FIRE SAFETY INSPECTION REPORT

POWERTEX FASHIONS LTD (UNIT- 1)

**(UNIT- 1) AYESHA TOWER , KAMARJURI , NATIONAL
UNIVERSITY, GAZIPUR**

February 7, 2015

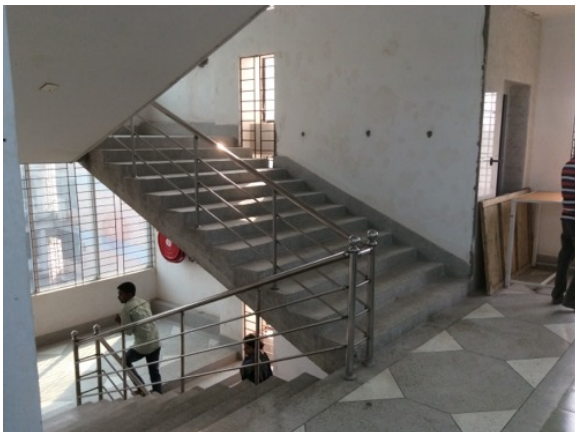
No.	Category	Finding	Recommendation	Remediation Timeframe
F-1	Fire Rated Construction	Rooms used for combustible storage on the ground floor are not separated by fire-rated construction.	Provide dedicated storage rooms separated by minimum 1-hr fire-rated construction. Where separate storage rooms are not feasible, provide defined storage areas and limit the storage arrangement as follows: - Maximum height of 2.45m (8ft.) and maximum area of 23m² (250 ft²) - If sprinkler protected: maximum height of 3.66m (12ft.) and maximum area of 93m² (305ft²) Separate areas of unenclosed combustible storage by a minimum clear distance of 3m (10ft.).	Within 3 months

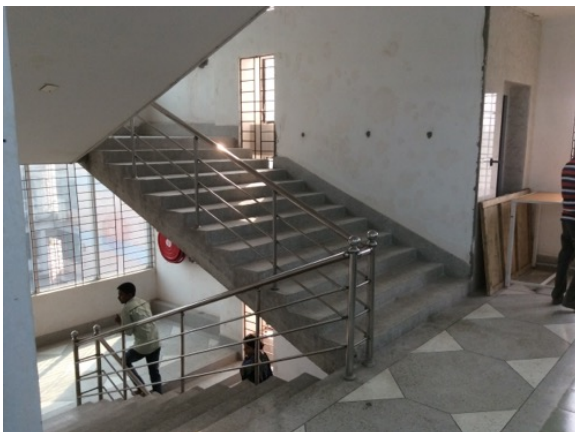
F-3	Fire Rated Construction	The exit stairs are not separated from work areas on each floor by fire-rated construction.	Provide minimum 1-hr rated doors for buildings with 3 or fewer stories and 1.5-hr fire rated doors for buildings that are 4 or more stories. Seal all unprotected openings to separate the exit stairs from work areas and other building spaces on all floor levels. Ensure that the fire doors are self-closing and positive latching and that they are provided with fire exit (panic) hardware where serving production floors. If fire doors are required to be held open for functional reasons, provide automatic-closing devices tied to the fire alarm system. Once fire doors are installed, every door in a stair enclosure serving more than 5 stories shall be provided with re-entry unless it meets ACCORD standard 6.8.3.1.	Within 3 months
-----	-------------------------	---	--	-----------------

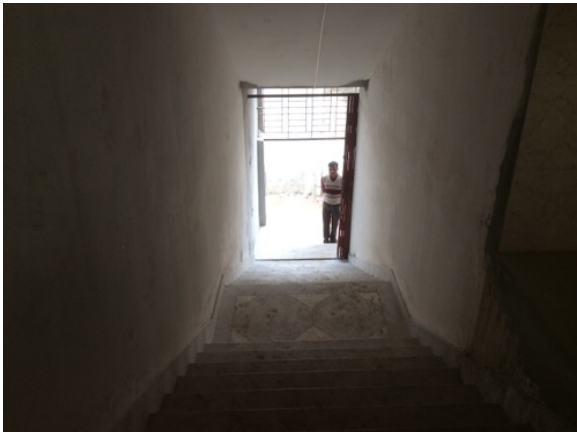
F-6	Egress	Building did not have stair designation signs, occupant load signs and emergency evacuation plans at required locations throughout the building.	Provide stair designation signs, occupant load signs and emergency evacuation plans at required locations.	Immediately
F-7	Egress	Egress gates with locking features are provided at ground floor building exits and exit discharge.	Remove locking features from all egress gates. If locks are required for security reasons, utilize special door locking features complying with NFPA 101 and ACCORD standard 6.8.2.	Immediately

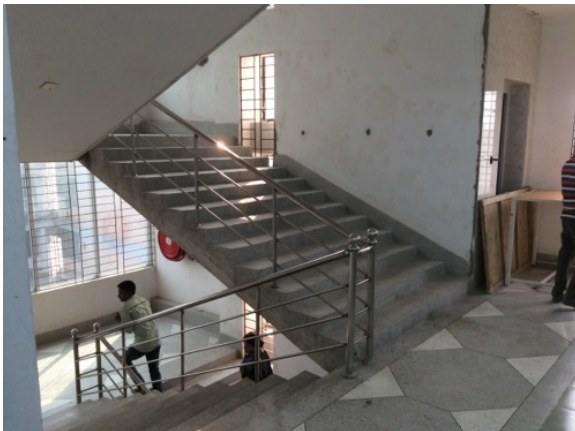
F-9	Egress	Exit stairs serve more than 5 stories and do not have required re-entry provisions. However it should be noted that exit stair doors have not yet been installed.	Every door in a stair enclosure serving more than 5 stories shall be provided with re-entry unless it meets ACCORD standard 6.8.3.1.	Within 3 months
-----	--------	---	--	-----------------

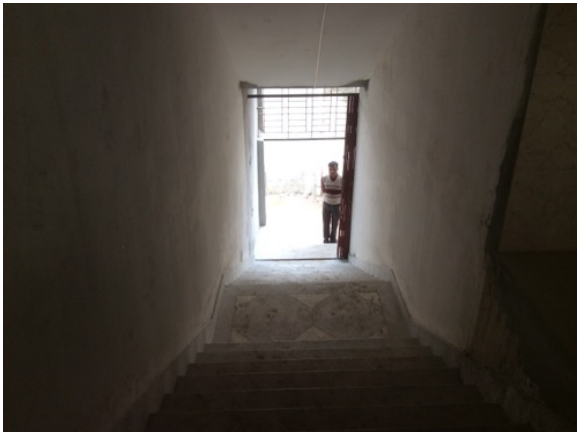
F-10	Egress	Exit stair door on the ground floor does not swing in the direction of egress travel.	Modify the egress door to swing in the direction of egress travel.	Within 3 months
------	--------	---	--	-----------------

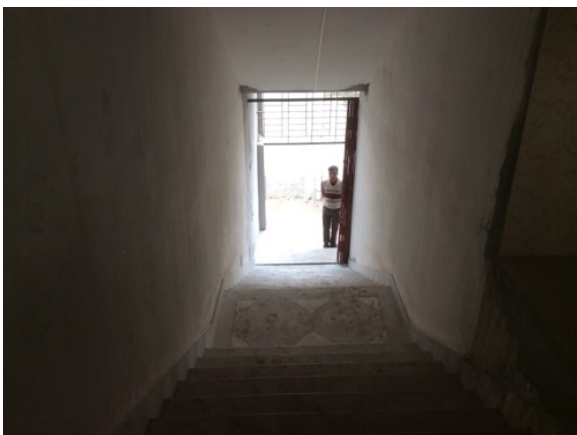
F-11	Egress	Handrails are not provided on both sides of both exit stairs.	Provide handrails on both sides of the exit stair. New handrails shall have a minimum height of 865 mm (34 in.) and a maximum height of 965 mm (38 in.) as measured from the leading edge of the tread. Intermediate handrails shall be provided when the stair width exceeds 2.2 m (87 in.)	Within 3 months
------	--------	---	--	-----------------
